DART AEROSPACE APICAL INDUSTRIES, INC. dba DART AEROSPACE		ENGINEERING CHANGE NOTICE NO. 05930				SHEET 1 OF 2		
		DWG NO. 649.5200		REV: B	PREPARED BY M. BELLAVANCE	DATE: 02/06/18		EFFECT ON DWG <input checked="" type="checkbox"/> INC. <input type="checkbox"/> UNINC.
		DWG TITLE: BRACKET						
TRANSACTION CODES (TC): A-ADD C-CREATE R-REVISE D-DELETE		APPROVED BY: ENGR 	MFG 	QC 	EFF. NEXT ORDER		ECR: 18-013	
<u>SHEET 1, ZONE A1 WAS:</u> NOTES: UNLESS OTHERWISE SPECIFIED <ol style="list-style-type: none"> 1 MATERIAL: 7075-T651 ALUMINUM PER AMS-QQ-A-250/12. 2 FINISH: HARD ANODIZE IAW MIL-A-8625 TYPE III, CLASS 2, COLOR: BLACK; PRETREAT PR-148 ADHESION PROMOTER, PRIME IAW MIL-P-23377J TYPE I, CLASS N. 3. DEBURR AND BREAK ALL SHARP EDGES. 4. IDENTIFY IAW MPP-120. LASER ENGRAVE CENTURY GOTHIC, 12 POINT P/N AND REVISION. 5 PART DIMENSIONS CONTROLLED BY CAD MODEL FILE: 649.5212 BRACKET.SLDPRT, LAST MODIFIED 11-02-11. 6 PART DIMENSIONS CONTROLLED BY CAD MODEL FILE: 649.5214 BRACKET.SLDPRT, LAST MODIFIED 11-02-11. 7 ALTERNATE MATERIAL: 0.125 INCH THICK 2024-T3 ALUMINUM SHEET METAL. 8 ALTERNATE MATERIAL: 7075-T6511 ALUMINUM PER AMS-QQ-A-200/11. 							ACTION ITEM: 1. SEND UPDATED DRAWING PAC

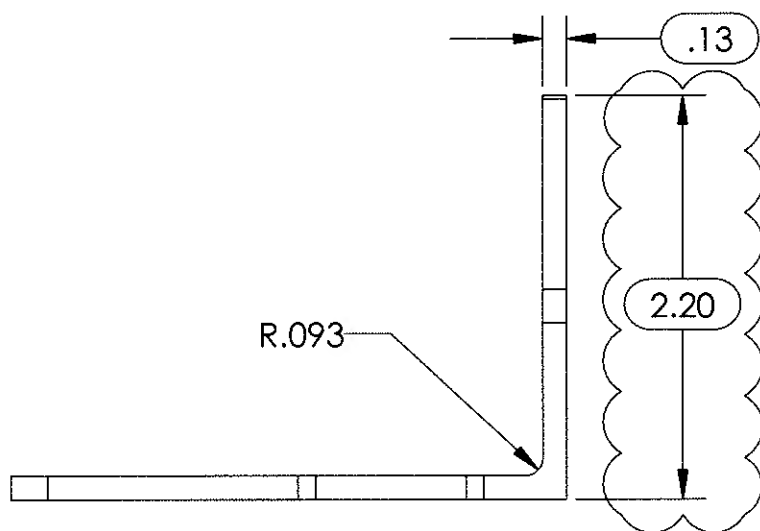
SHEET 3, ZONE C3 WAS:

SHEET 3, ZONE C5 WAS:
